SOUTH CAROLINA ELECTRIC & GAS COMPANY

June 22, 1982

Subject: Virgil C. Summer Nuclear Station  
Docket No. 50/395  
IEB 79-02

Request for Additional Information on IEB 79-02

## SERVICE 4-BOLT PLATE W/ TENSILE LOAD & BENDING

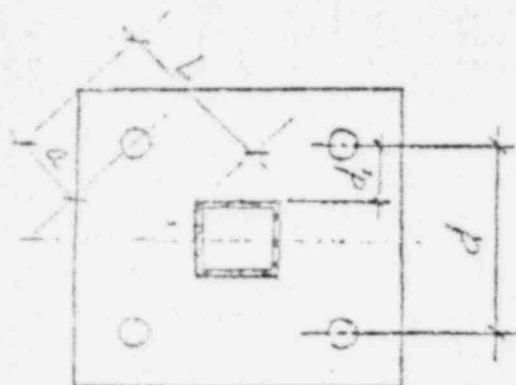
$F_Y, M_Z$  ACTING  
USING TES EP-2-010,  
FIND AMPLIFICATION FACTOR,  $\phi$   
BASED ON  $a/L$  RATIO.  
NOTE: MOMENTS ARE REACTED  
BETWEEN BOLT CENTERLINES.

$$T_{BOLT} = \phi \left( \frac{F_Y}{4} + \frac{M_Z}{2d} \right)$$

TO CHECK BOLT INTERACTION  $\frac{T_B}{T_A} + \frac{V_B}{V_A} \leq 1.0$   
WHERE  $T_A$  = BOLT TENSION ALLOWABLE

NOTE: TES ASSUMES ONLY 1/2 THE BOLTS ACTING IN SHEAR.

FOR THIS CASE,  $\frac{T_{BOLT}}{T_{ALLOW}} \leq 1.0$  \*

TO CHECK BASEPLATE STRESS ( $S_x$  = SECTION MODULUS OF BASEPLATE)

$$PLATE \text{ STRESS, } f_b = 2 \times T_{BOLT} \times d_1 / S_x$$

$$f_b \leq 0.75 F_Y^* \text{ OF BASEPLATE MATERIAL}$$

\* NOTE: IF EITHER OF THESE ALLOWABLES ARE EXCEEDED,  
A MODIFICATION WOULD BE REQUIRED, IE  
GUSSET PLATES, OR REPLACEMENT OF BOLTS.

### RECTANGULAR 6-BOLT PLATE W/ TENSILE LOAD & BIAxIAL BENDING

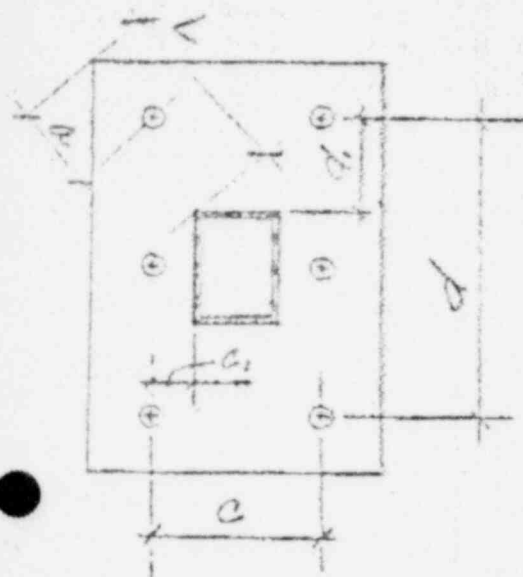
$F_y, M_x, M_z$  ACTING  
INITIAL CALCULATION TRIAL  
MAY BE USING 4-BOLTS ACTING  
GENERALLY, GUSSET PLATES ARE  
NEEDED TO BETTER UTILIZE THE  
BOLT CONFIGURATION CAPACITY  
SINCE THE PEYING FACTOR IN  
TES EP-2-D10 BECOMES PRO-  
HIBITIVELY LARGE WHEN CONSIDERING  
ONLY FOUR BOLTS IN THIS CASE.  
CONSIDERING THE LOAD DISTRIBUTION,  
WITHOUT GUSSET PLATES, THE  
TWO MIDDLE BOLTS WOULD  
GENERALLY BE OVERLOADED

FROM TES EP-2-D10, DETERMINE  $\phi$  FROM  $e/L$

$$T_B = \phi \left( \frac{F_y}{6} + \frac{M_x}{3C} + \frac{M_z}{2d} \right) \quad \phi = 1.0 \text{ FOR RIGID PLATE CONSERVATIVE}$$

INTERACTION  $T_{BOLT} / T_{ALLOW} \leq 1.0$

PLATE STRESS  $S_x, S_z$  B.R. SECTION MODULUS

$$f_b = \left( \left( \frac{2 \times T_B \times d_1}{S_z} \right)^2 + \left( \frac{3 \times T_B \times C_1}{S_x} \right)^2 \right)^{1/2}$$

$$f_b \leq 0.75 F_y \text{ BASEPLATE MATERIAL}$$

NOTE: IF THE ESTIMATE FOR  $f_b$  IS TOO CONSERVATIVE,  
A FINITE ELEMENT PROGRAM CAN BE RUN FOR  
A BETTER APPROXIMATION.

### SQUARE B-BOLT PLATE W/ BIAXIAL BENDING

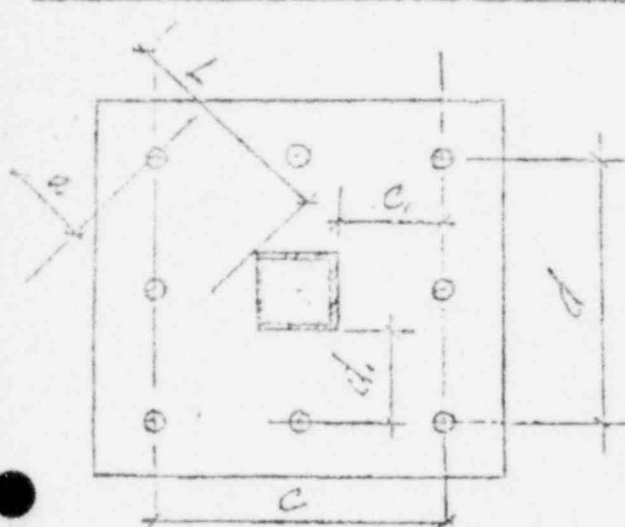
$M_1, M_2$  ACTING

ONE CONSERVATIVE APPROACH  
TO ANALYZE B-BOLT PLATES  
IS TO ASSUME ONLY  
4 BOLTS ACTING.  
IF THIS PROVES TOO CONSERVATIVE,  
ALL EIGHT BOLTS ARE UTILIZED  
DETERMINE AMPLIFICATION FACTOR  $\phi$   
BASED ON  $a/L$  RATIO.

$$T_{BOLT} = \phi \left( \frac{M_1}{3C} + \frac{M_2}{3d} \right) \text{ (MAXIMUM)}$$

CHECK  $T_{BOLT} / T_{ALLOW} \leq 1.0$  BOLT INTERACTION

BASEPLATE STRESS  $S_X = S_Z =$  SECTION MODULUS OF P. PL.

CONSERVATIVE ESTIMATE -

$$f_b = \left( \left( \frac{3 \times T_{BOLT} \times C_1}{S_X} \right)^2 + \left( \frac{3 \times T_{BOLT} \times d_1}{S_Z} \right)^2 \right)^{1/2}$$

$$f_b \leq 0.75 F_Y \text{ OF BASEPLATE MATERIAL}$$

NOTE: IF THE ESTIMATE FOR  $f_b$  IS TOO CONSERVATIVE  
A MORE DETAILED HAND CALCULATION CAN BE  
MADE TO DETERMINE INDIVIDUAL BOLT LOADS,  
OR A FINITE ELEMENT PROGRAM CAN BE RUN  
TO ANALYZE THE BOLT LAYOUT.

\* SHORT DIRECTION PRYING FACTOR FOR ANGLE BASEPLATES  
TEL DID NOT HAVE ANY ANGLE BASEPLATES IN WORK SCOPE.

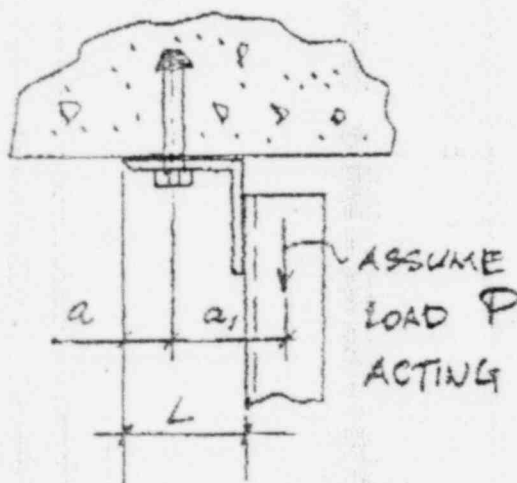
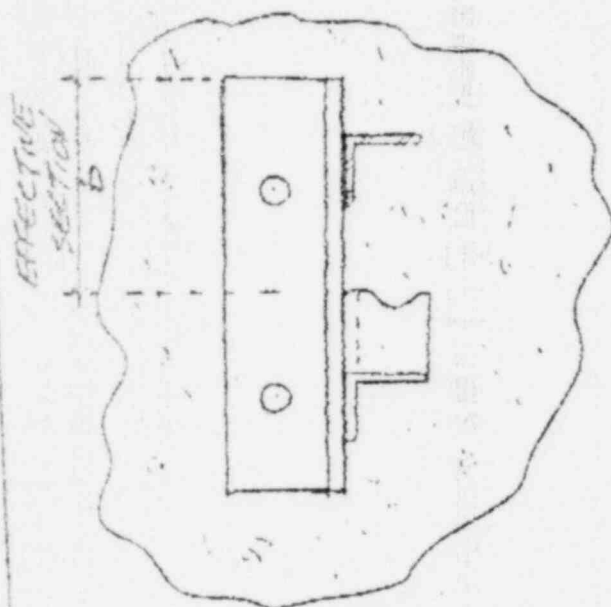
THE AMPLIFICATION FACTOR,  $\phi$ ,  
SHOWN IN TES PROCEDURE  
EP-2-010 INCLUDES THE  
EFFECT OF THE FLEXIBILITY OF  
THE ANGLE WHOSE INSIDE  
ATTACHED LEG BEHAVES  
LIKE A BASEPLATE.

FIND THE AMPLIFICATION FACTOR,  $\phi$   
BASED ON  $a/L$ .

$$T_{BOLT} = \phi P$$

$$T_{BOLT} / T_{ALLOW} \leq 1.0$$

CHECK ANGLE LEG BENDING

$$f_b = \frac{T_{BOLT} \times a_1}{S}$$

SECTION MODULUS BASED  
ON EFFECTIVE SECTION

$$f_b \leq 0.75 F_y \text{ OF ANGLE MATERIAL}$$

\* NOTE: THIS IS HOW TES WOULD ADDRESS ANGLE  
BASEPLATES IF THERE WERE ANY IN OUR SCOPE.

FIGURE 1

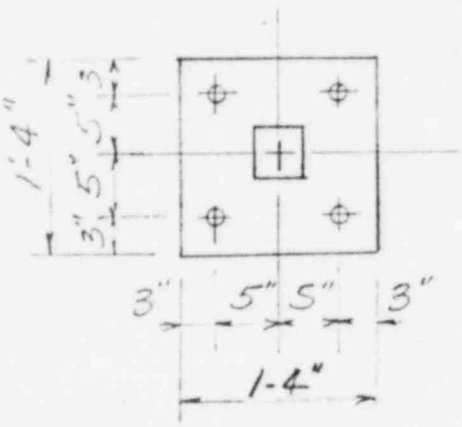
Provide a numerical example for each of the following flexible plate and bolt configurations which was used to determine allowable axial loads and bending moments.

- a. square plate/four bolts, eight bolts
- b. rectangular plate/six bolts

GILBERT ASSOCIATES, INC. ENGINEERS AND CONSULTANTS READING, PA.	DEPARTMENT NAME STRUCT. ENG.	DEPT. NO. 0412	FILING CODE 0.13.11
	PROJECT NAME VC SUMMER Nuc' STN. UNIT #1	W.O. NUMBER 02-6461-020	PAGE 2
SUBJECT RESPONSE TO QUESTION 2 - NRC DOCKET No. 50-395		ORIGINATOR W. J. [Signature]	
<p>EXAMPLE: SQUARE PLATE W/ FOUR ANCHORS.</p> 		DATE 5-26-82	
		VERIFIER R. M. [Signature]	
		DATE 5-27-82	
<p>GIVEN :</p> <p>BASE PLATE = 16" x 3/4" x 1'-4"</p> <p>ATTACH. SIZE = 4" x 4"</p> <p>ANCHOR = 1" Ø Hilti "Kwik Bolt"</p> <p>TENSION LOAD = 4.5 K = <math>F_z</math></p> <p>BEND. MOMENT = 38.0 K-in. = <math>M</math></p> <p><math>T_o = 3.75</math> K</p>			
<p>CALCULATE ANCHOR TENSION LOAD:</p> $P_T = \frac{F_z}{4} + \frac{M}{2(10)} = \frac{4.5}{4} + \frac{38}{20} = 1.125 + 1.9 = 3.025 \text{ K}$			
<p>CHECK FACTOR OF SAFETY:</p> $F_{P_2} = \frac{1}{\frac{2P_T}{T_o} + \frac{V_{T0}}{V_o}} = \frac{1}{\frac{2(3.025)}{3.75}} = 0.62 < 1.0 \quad \text{No Good}$

<p>RUN FLEXIBLE PLATE PROGRAM:</p> <p>OUTPUT :</p> $\begin{aligned} F_T &= 1.125 \text{ K} & F_{P_T} &= 0.0 \text{ (No Pry)} \\ F_M &= 2.517 \text{ K} \\ F_{P_M} &= 0.064 \text{ K} \\ T &= 3.706 \text{ K} \end{aligned}$			
<p>FACTOR OF SAFETY</p> $F_{P_2} = \frac{1}{3.706/3.75} = 1.01 > 1.0 \therefore \text{OK}$
